ADDENDUM NO. 1

FOR: Little Rock Medical Clinic

August 25, 2026

A111

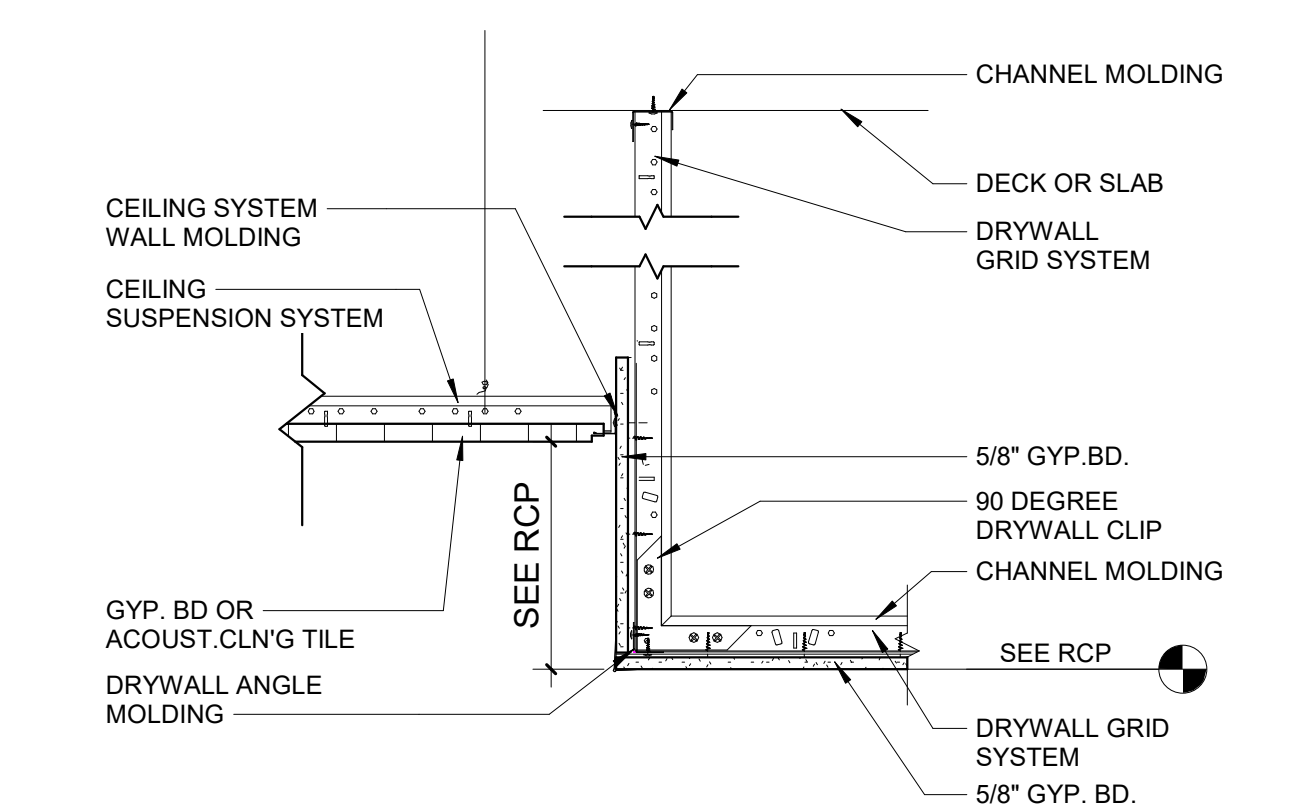
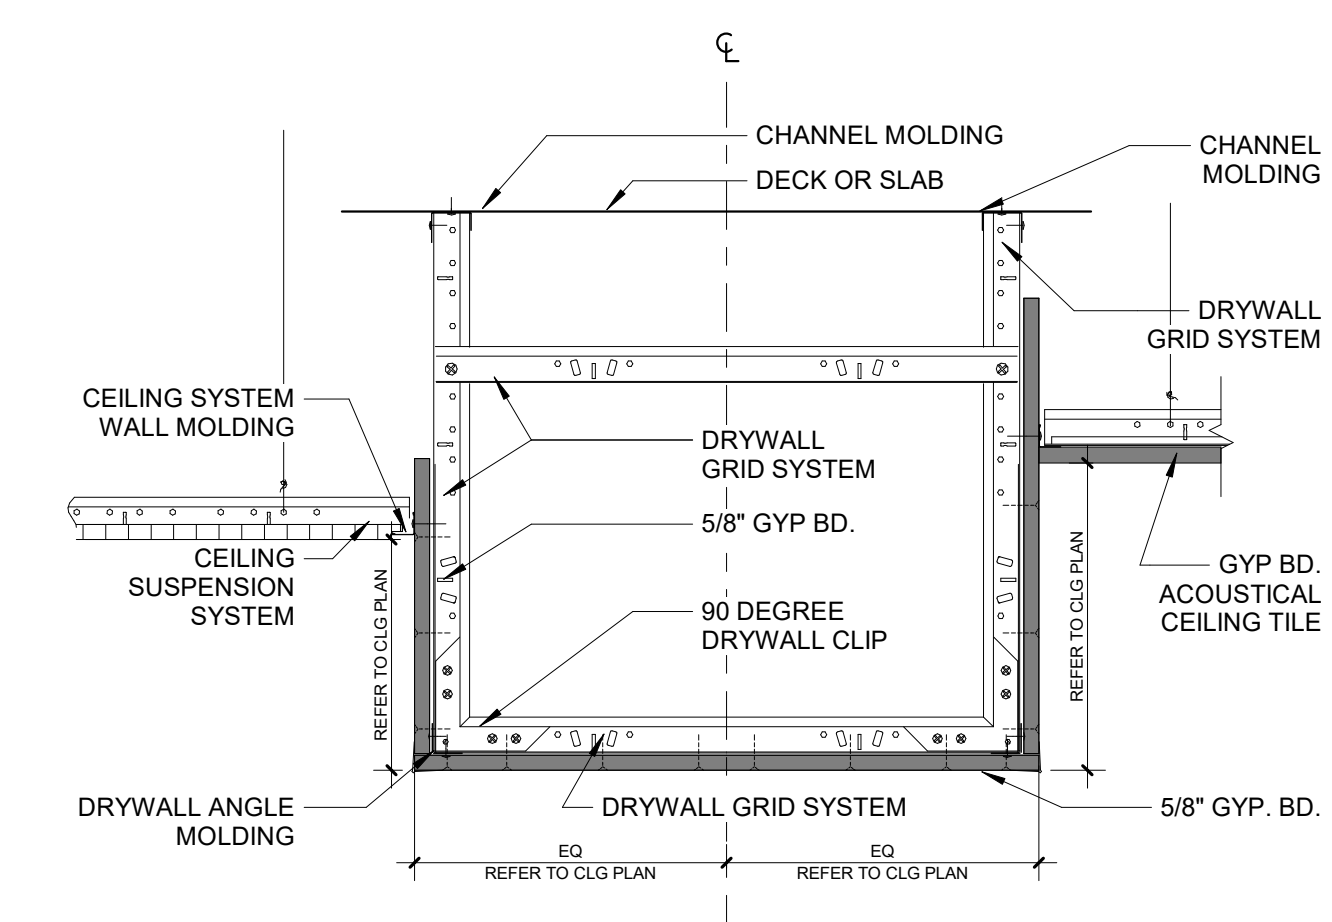
Answer:

Bottom face of the baffles should align with the adjacent gyp ceiling at 10'-0" AFF. Baffles are 10" tall. Info to be included in Addendum #1.
